UNITED STATES PATENT AND TRADEMARK OFFICE

APPLICATION NO.	FILING DATE	FIRST NAMED INVENTOR	ATTORNEY DOCKET NO.	CONFIRMATION NO.
09/960,306	09/24/2001	Donald Richard LaCoy	20272/0688	5354

Office Action Summary

DETAILED ACTION

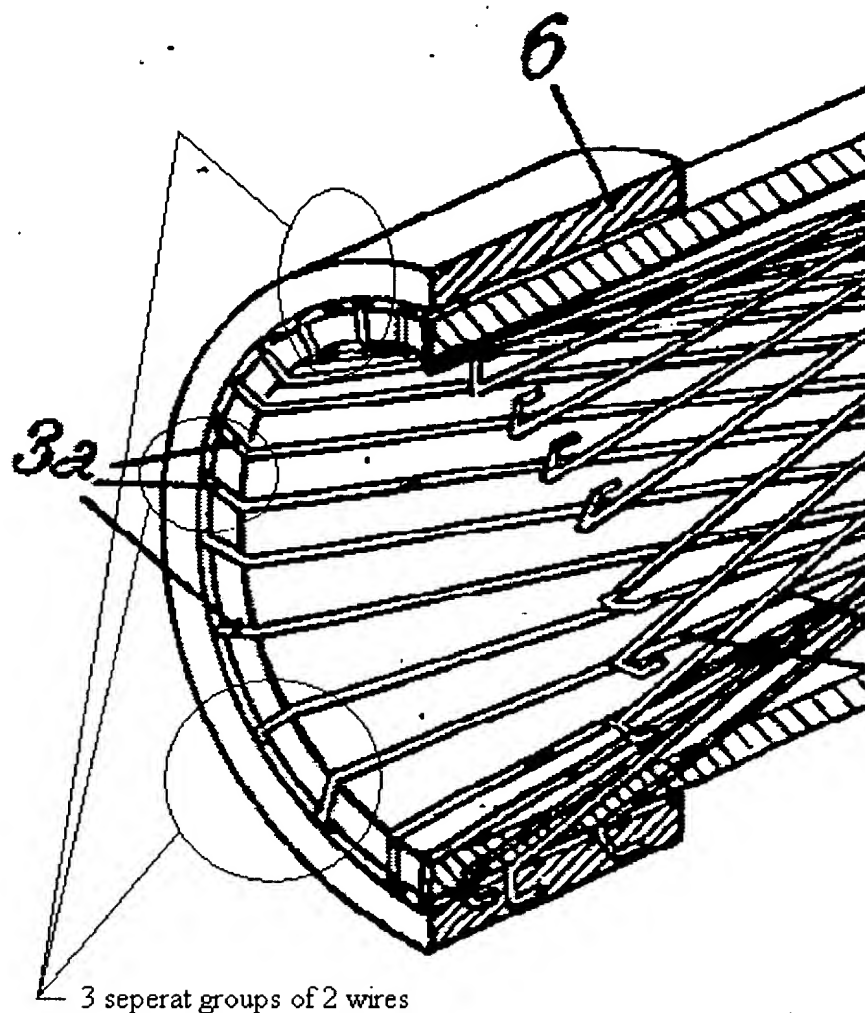
-- In reference to claim 1, Bonhomme shows (figures 2 and 6)

a retaining structure 12 and a plurality of resilient wires 3 extending along the socket in a hyperboloid arrangement and exposed for contact with a male 11 contact member inserted within the socket, wherein

the wires are arranged in groups of at least two wires each (see examiner's detail of Bonhomme's figure 2), and wherein the spacing of the wire in each group is closer than that of the groups from one another.

-- In reference to claim 5, Bonhomme shows (figures 2 and 6)

a first support member 6 at one end;

a second support member 7 at an opposite end;

a first pair of resilient contact wires extending along the socket at an angle to its axis, the wires being attached with the first and second support members at opposite ends;

a second pair of resilient contact wires extending along the socket at an angle to its axis, the second pair of wires being spaced around the socket from the first pair and being attached with the first and second support members at opposite ends; and

a third pair of resilient contact wires extending along the socket at an angle to its axis, the third pair of wires being spaced around the socket from the first and second pair (see examiner's detail of Bonhomme's figure 2) and being attached with the first and second support member at opposite ends such that

the three pairs of wires make a hyperboloid arrangement and are exposed for contact with a male 11 contact member inserted with the socket.

-- In reference to claims 3 and 11, the socket includes three groups of two wires each (see examiner's figure) .
